North Elevation (Window spec section 1.3). painted shut. age (Section 1.5)

South Elevation (Window spec section 1.3). all painted shut. age (Section 1.5)

South 1:50

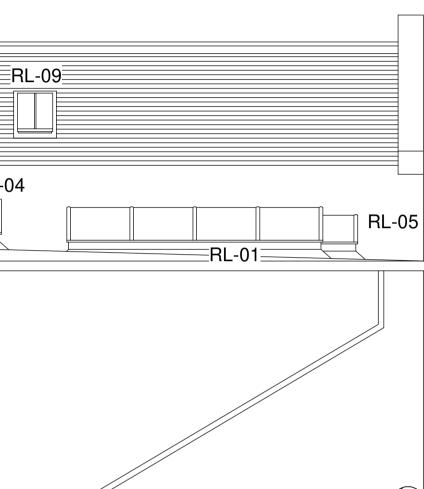
FF 20-22 Remove existing Triple leaded light and dispose. Manufacture supply and install new Triple fixed light with leaded detail to match existing with privacy glass fitted.

Allow for 80% of windows on North elevation to to have sills replaced

Allow for 100% of putty to be replaced. Allow for 80% of the sash frames to be reburbished. Unknown the full extent due to windows being painted shut.

Allow for paint removal (Section 1.8) on 50% of the windows. FF 1-7 all

Allow for 80% of windows ironmongery to be replaced due to wear and

Allow for 70% replacement of the sash cords and weights (Section 1.9)

Allow for 90% of windows on North elevation to to have sills replaced

Allow for 100% of putty to be replaced. Allow for 80% of the sash frames to be reburbished. Unknown the full extent due to windows being painted shut.

Allow for paint removal (Section 1.8) on 40% of the windows. GF 16-19

Allow for 90% of windows ironmongery to be replaced due to wear and

Allow for 90% replacement of the sash cords and weights (Section 1.9)
